NOTICE TO APPLICANTS ADDENDUM NO. ONE (1)

Faver-Dykes State Park – Upgrade Fishing Dock DEP Bid NO. BDC37-19/20

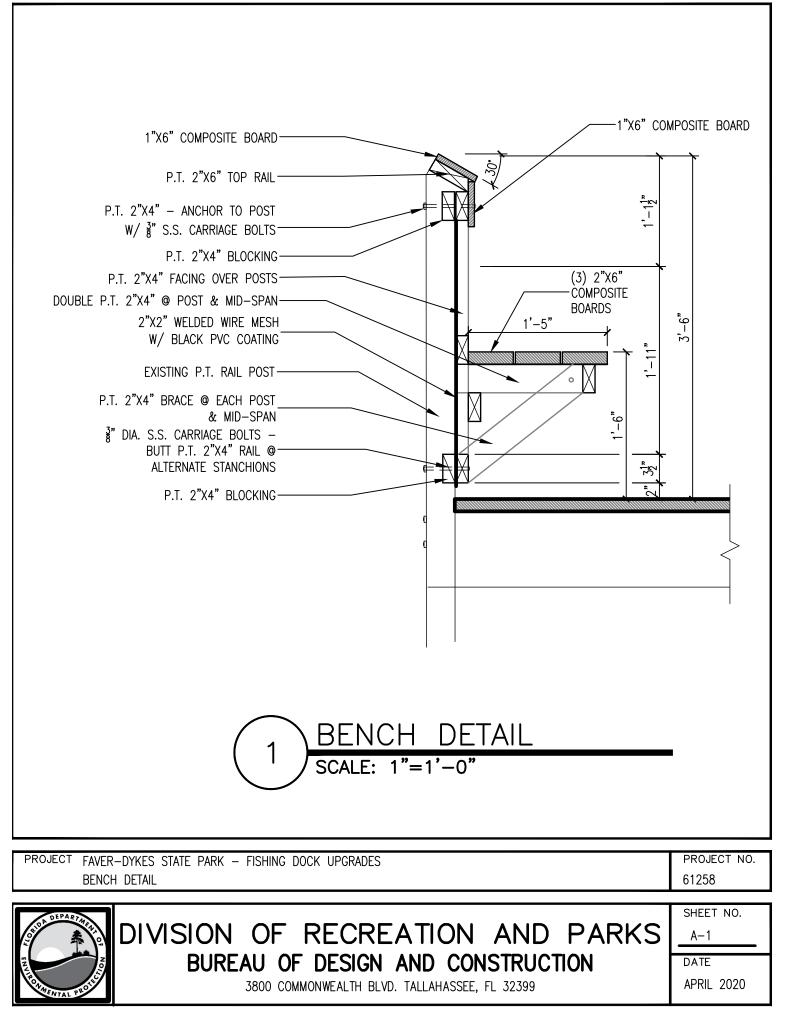
- Question: In Reference to "Scope of Work" Bid document Page 3 of 3, Item 6 Benches; Where am I to find the new bench detail in the bid package? Answer: See attached detail A-1.

- Question: Please provide new bench detail or specify that the new bench detail is to match existing bench construction in conformance with dimensional timber requirements of section 06100 Rough Carpentry, or other?

Answer: See attached detail A-1.
- 6. Question: Some cap boards and cap to pile mounting hardware of the existing structure are damaged. I am unable to locate a section of the bid package that identifies timber bent cap replacement. Will there be any requirements for new Timber Bent cap replacement once new pile(s) are driven? If so, please provide connection detail and frequency or repairs? Answer: Match existing installation.
